Design Review No. SR 91-55

WALNUT CREEK DESIGN REVIEW COMMISSION
RESOLUTION NO. 1815
SIGN REVIEW APPLICATION NO. 91-55
CITRUS PLAZA SIGN PROGRAM

SUBJECT: SIGN REVIEW APPLICATION NO. 91-55 - CITRUS PLAZA SIGN PROGRAM. A request for approval of a modification to a previously approved sign program for an existing commercial office building at 3021 Citrus Circle.

SHEET 1 OF 4.

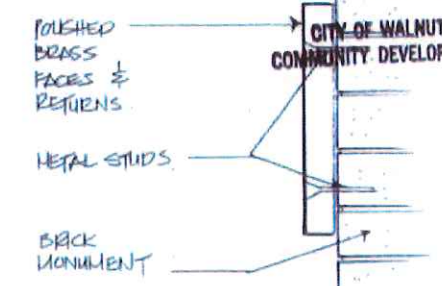
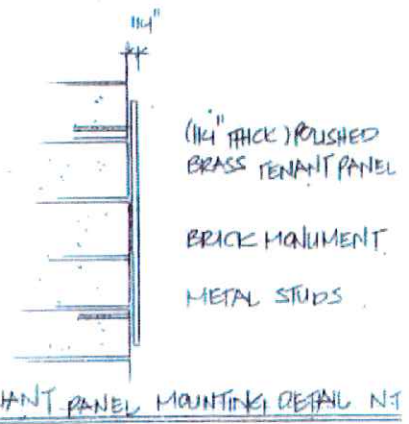
PAINT OFF WHITE TO MATCH THE BRICK
BRICKS TO MATCH THE BLDG.
PAINT OFF WHITE TO MATCH THE BLDG.

MANUFACTURE ONE 8'-0" BY 14'-0" BRICK MONUMENT TO MATCH THE BUILDING.
10" (CITRUS PLAZA) TO BE IN REVERSE CHANNEL LETTERS W/ POLISHED BRASS
FACES & 1/2" POLISHED BRASS RETURNS.
(6) 12" BY 6'-3" TENANT NAME PANELS TO BE (1/4" THICK) POLISHED BRASS.
TENANT NAMES TO BE DEEP HAND. BROWN # 220-19.
LETTERS & PANELS TO BE STUD MOUNTED ON THE BRICK MONUMENT AS SHOWN.
REMOVE EXISTING GROUND LIGHTING FIXTURES & REINSTALL ON EACH END OF
THE MONUMENT SIGN.

1. The overall height of the freestanding sign shall not exceed eight (8) feet above grade.
2. The number of tenants listed on the freestanding sign shall not exceed six (6).
3. Details of the proposed ground lighting for the freestanding sign shall be submitted for review and approval by the Planning Division.
4. A building permit must be obtained prior to installation of the sign.

TYPICAL FASCIA ELEVATION.

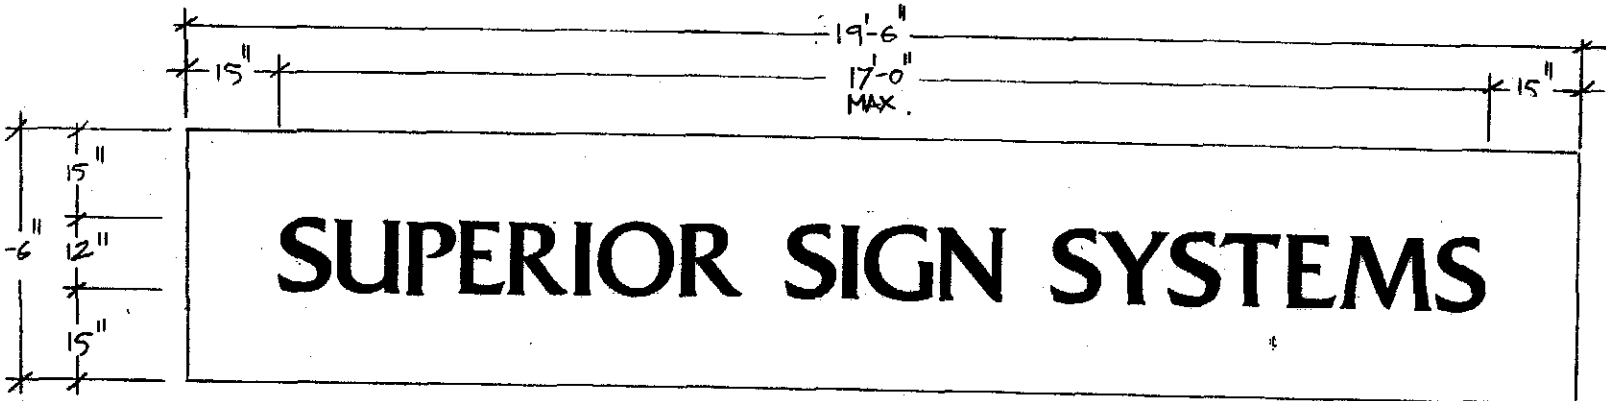
IDENTIFIES MAJOR TENANT W/ NON-ILLUMINATED SIGNAGE CONSISTING OF INDIVIDUAL REVERSE PAN-CHANNEL LETTERS W/ POLISHED BRASS FACES & 2" POLISHED BRASS RETURNS.
 LETTERS STYLE: _____ FRITZ QUADRADA.
 LETTERS HEIGHT: _____ MAXIMUM OF 12" HIGH.
 LETTERS LENGTH: _____ MINIMUM OF 15" ON EACH SIDE OF THE FASCIA BAND.

1. The tenant signs are not approved.
2. Details of the proposed ground lighting for the freestanding sign facing Oak Grove Road shall be submitted for review and approval by the Planning Division. The other sign shall not be lighted.
3. A building permit must be obtained prior to installation of the signs.
